### Comprehensive Audit:

1. Name of the Sub-Station: 220/132/66/33 kV 2x100 MVA Insulated
2. Voltage level: 220 kV
3. Owner: AEGU
4. Date of Audit: 13/11/2021
5. Members of Auditing Team:

# Audit Observations / Recommendations of 220/132 KV Tinsukia SS

SINGLE LINE DIAGRAM OF 220/132/66/33 KV, TINSUKIA SUBSTATION

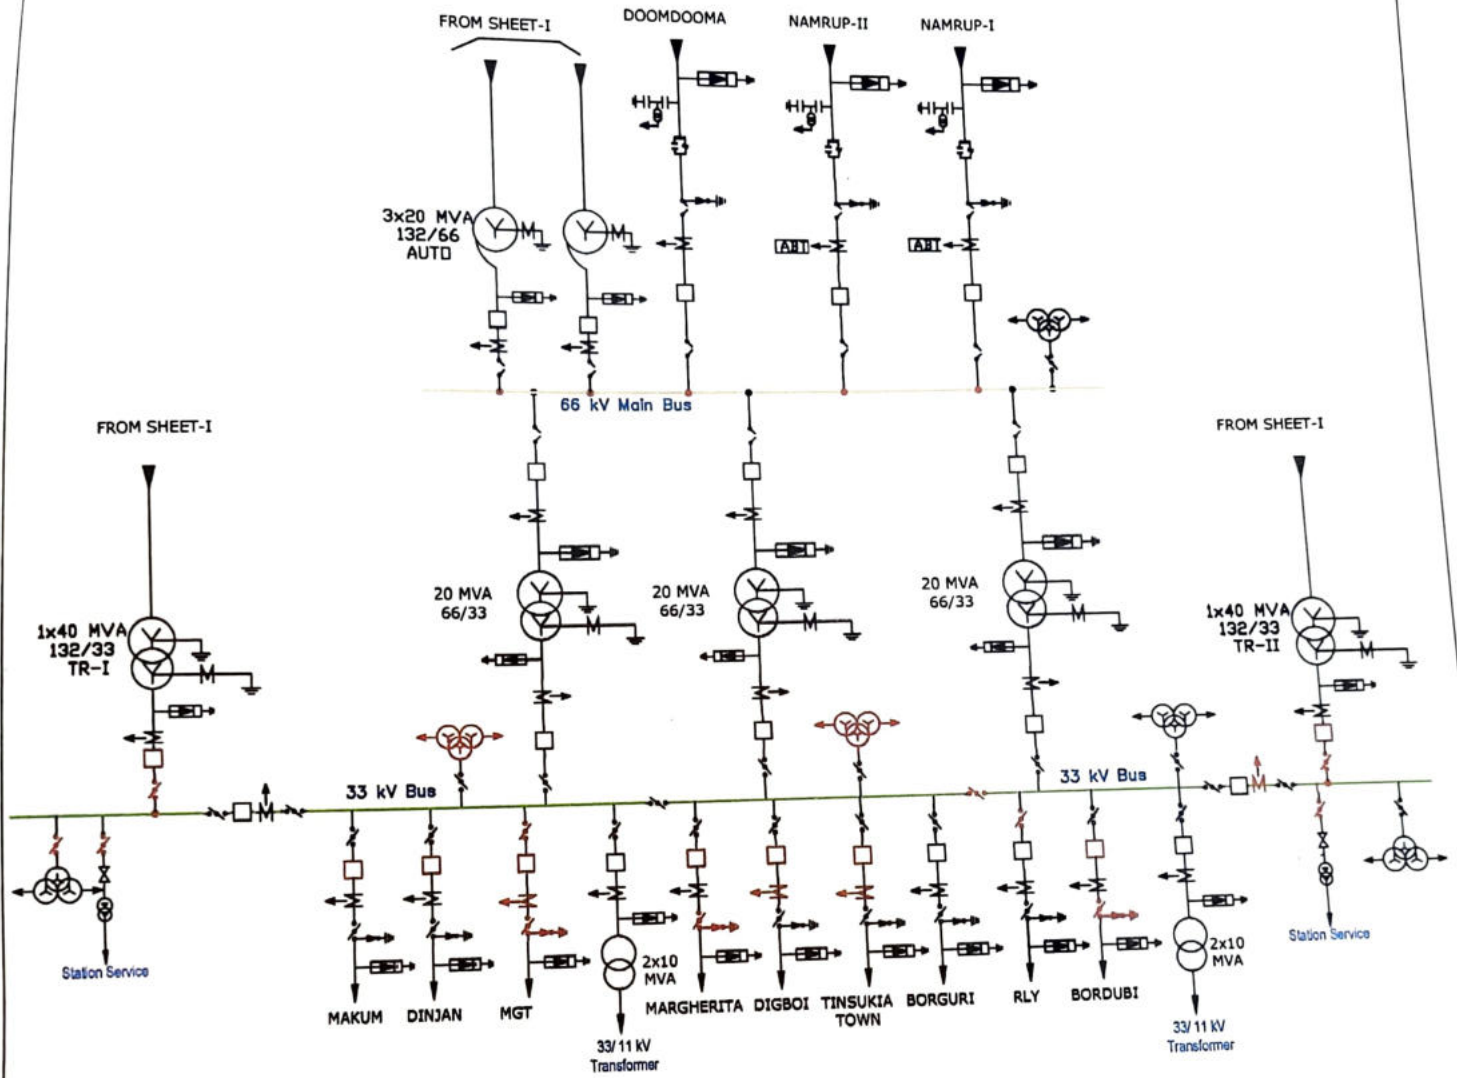
\* All feeders (220kV) connected to Bus-1. Feeders to be segregated.

Status
<u>220KV ISO</u>			
89T	→	N/A	(Not available)
40MVA Tr 2	89T	→	N/A
<u>132KV ISO</u>			
132KV TBC	89T	→	N/A
132KV TBC	89A	→	N/A
RUPAI	89T	→	N/A
MARGH- ERITA	89T	→	N/A
BORDUBI	89T	→	N/A
DIBRUGARH	89T	→	N/A
40MVA Tr 1	89T, 89A, 89L	→	N/A
40MVA Tr 2	89T, 89A, 89L	→	N/A
